From: Joseph B. Brady
To: Brian Bonser, Bruce Mallett, Carolyn Evans, Cha...
Date: Mon, May 17, 1999 1:52 PM
Subject: Re: Fwd: [NRC_CONCERNS] UCS Allegations re: Spent Fuel Storage at Harris Nuclear Plant

Spent Fuel Pool C and D Activation Protect Thermal-Hydraulic Analysis
(TITLE INCLUDING STRUCTURE/SYSTEM/COMPONENT)

SHEARON HARRIS NUCLEAR POWER PLANT X

Figure 1

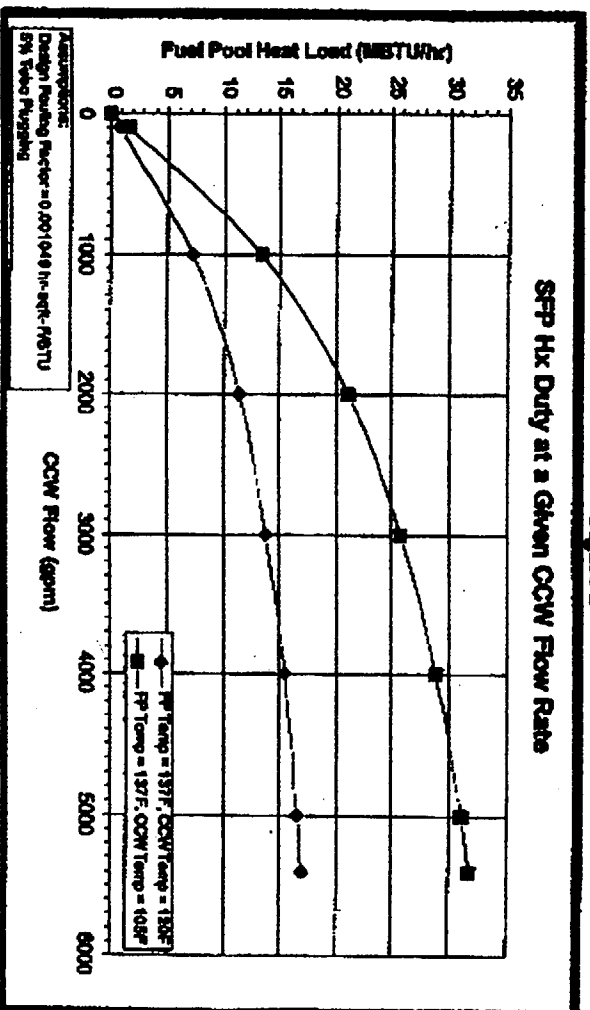
CP&L came to me this morning with a copy of the allegation. They were sent a copy via E-mail by Mr. Lochbaum on May 14. The numbers that he is concerned about (5400 gpm) for the existing A&B pools were used as worst case assumptions for the C&D pool calcs. The calc assumed that A&B would get max flow. The FSAR (section 9.1.3.3) states that the required flow for A&B pool SFP heat exchangers is 1789 gpm. I have faxed a copy of the appropriate pages of the calc to George MacDonald and Brian Bonser.
